IN SERVICE INSPECTION

REV. 13	ISO. NO.: MCFI INI50	DUKE PIPING CLASS: ASME SECTION III, CLASS B SPECIAL
		SYSTEM SYMBOL: SAFETY INJECTION SYSTEM
		BUILDING: REACTOR
		ZONING: R4
		PIPING SPEC.: NI-58 PS-2501.2; NI-113 PS-2501.1
		DRAWING NO.: MC-1414-09-20-07-08 Rev. 10/18/77
		PROJECT: MCQUIRE

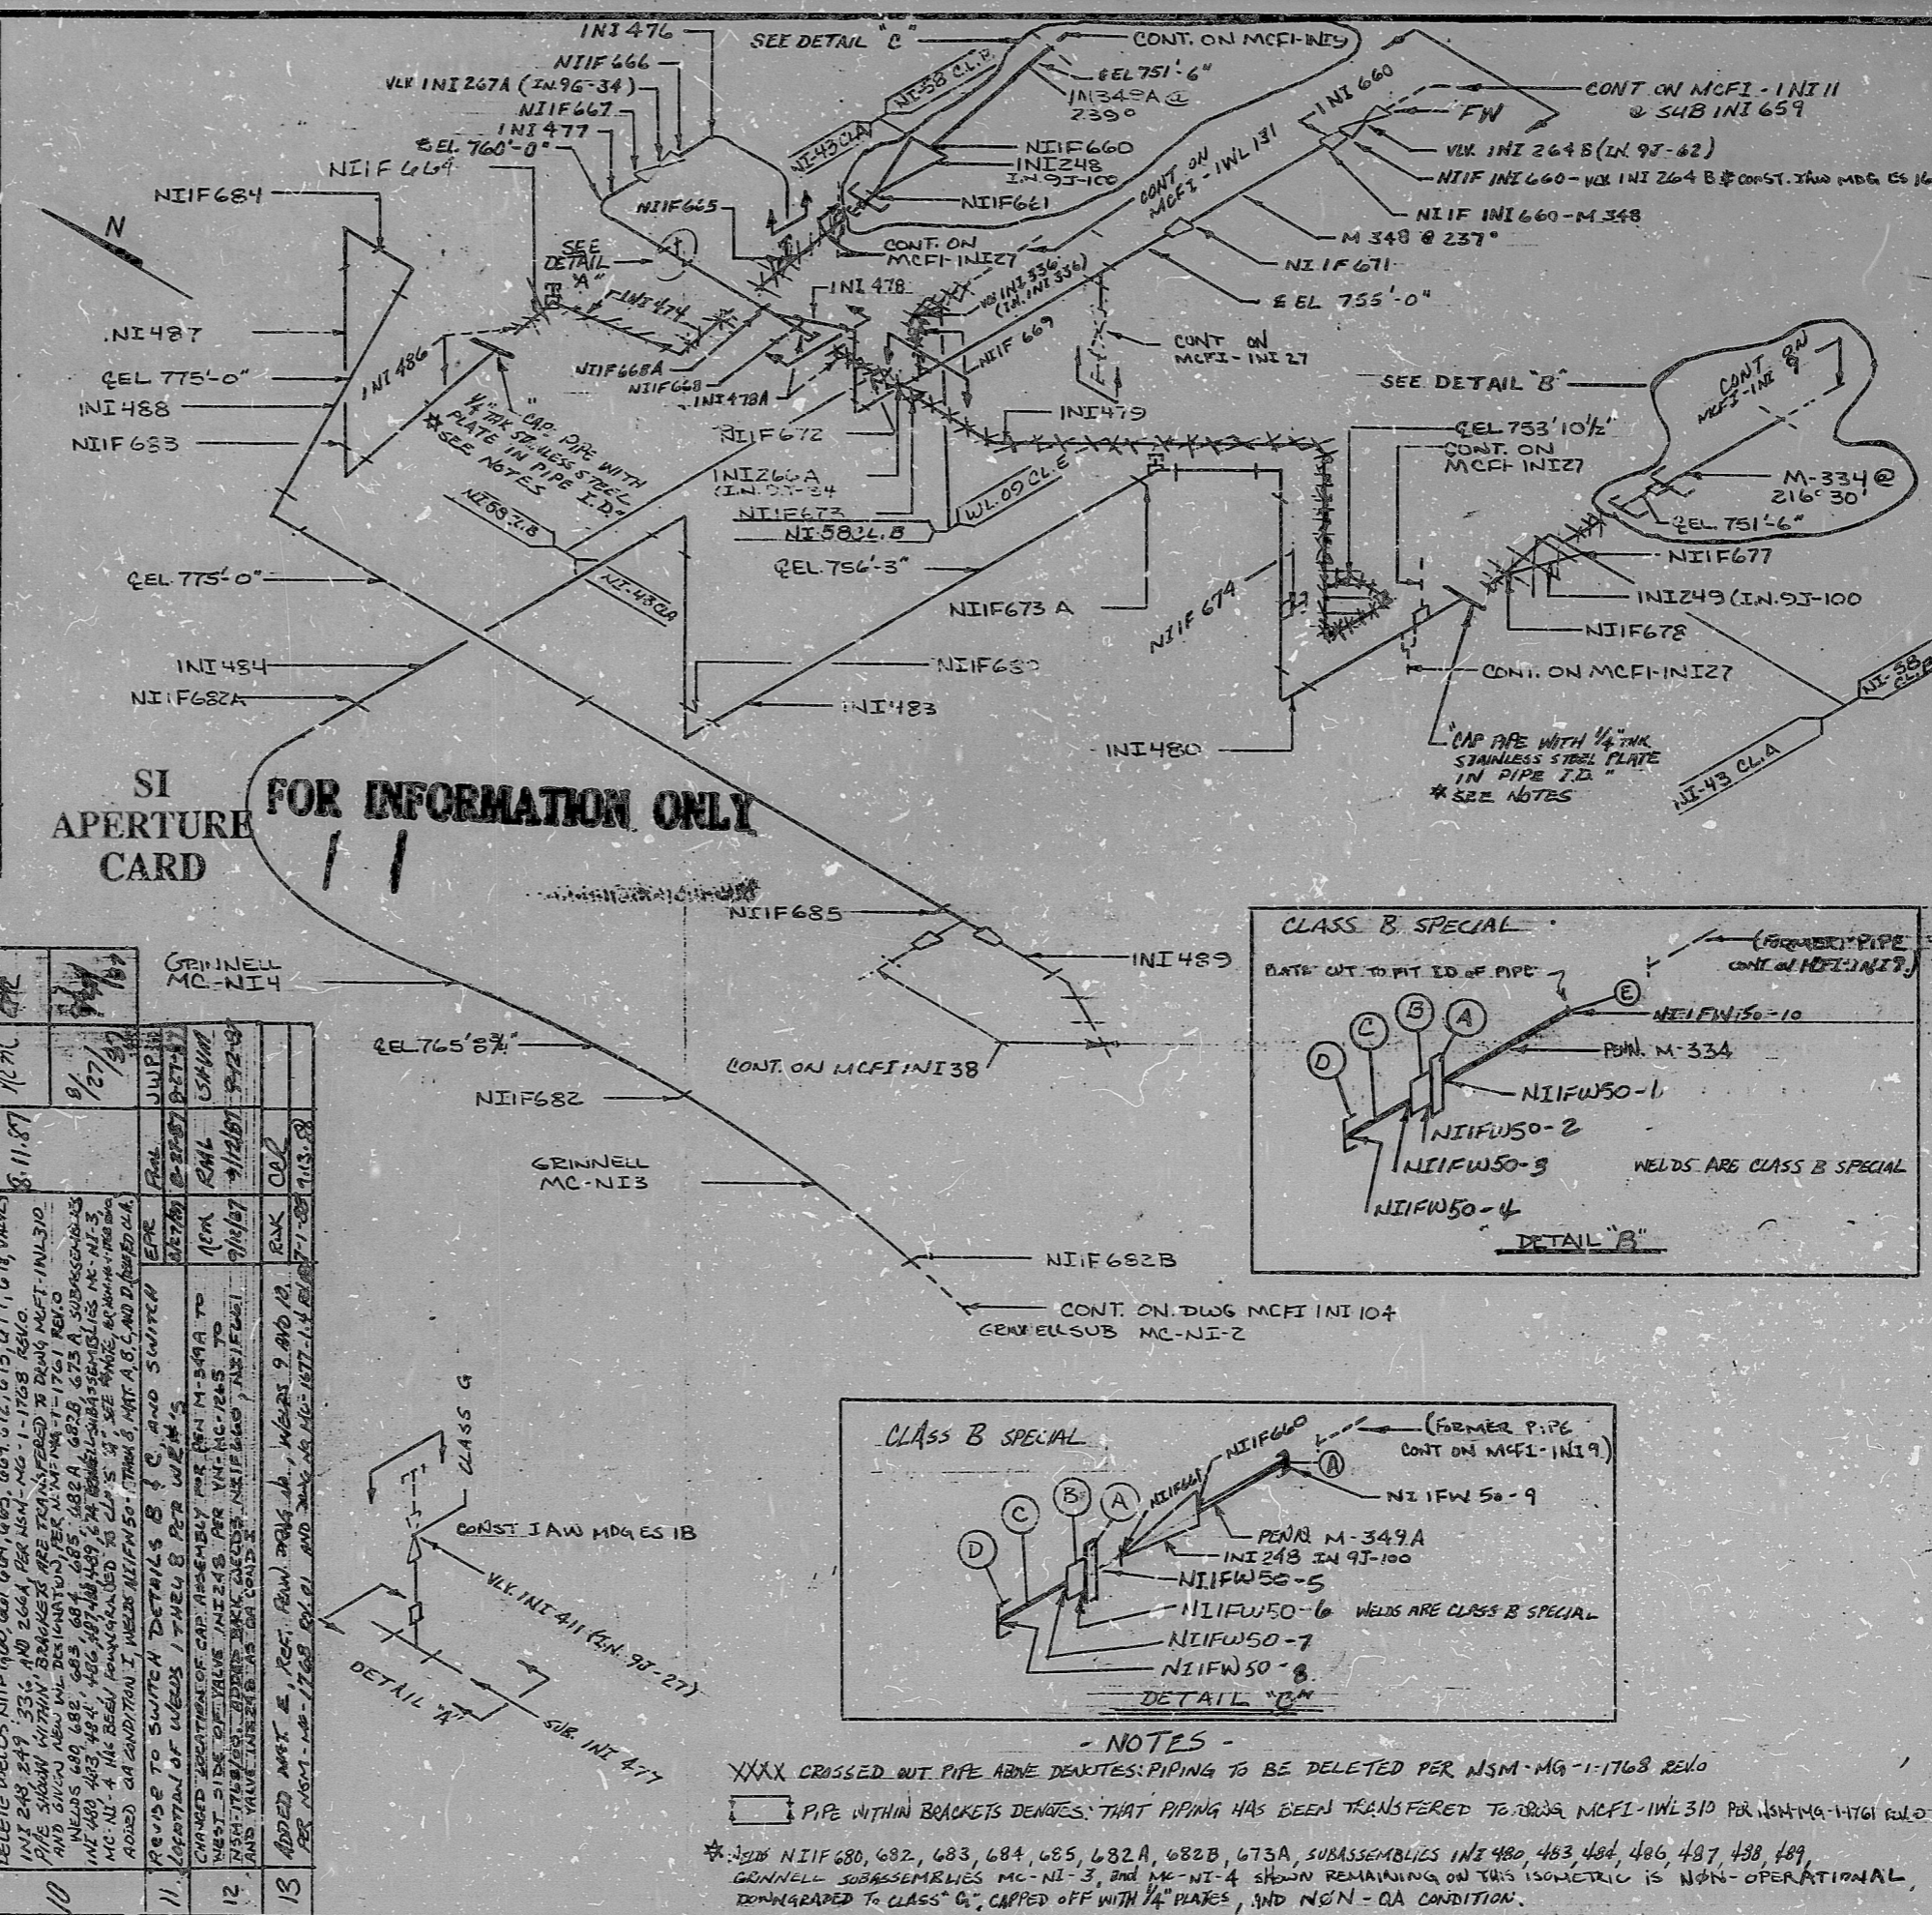
NOTES  
 XXXX CROSSED OUT PIPE ABOVE DEVICES: PIPING TO BE DELETED PER NSM-MG-1-1768 REV.0  
 PIPE WITHIN BRACKETS DENOTES THAT PIPING HAS BEEN TRANSFERRED TO BR3A MCFI-INI 310 PER NSM-MG-1-1761 REV.0  
 \* 3/28 NIIF 680, 682, 683, 684, 685, 682A, 682B, 673A, SUBASSEMBLIES INI 480, 483, 484, 486, 487, 488, 489, GRINNELL SUBASSEMBLIES MC-NI-3, AND MC-NI-4 SHOWN REMAINING ON THIS ISOMETRIC IS NON-OPERATIONAL, DOWNGRADED TO CLASS 'C', CAPPED OFF WITH 1/4" PLATES, AND NON-OA CONDITION.
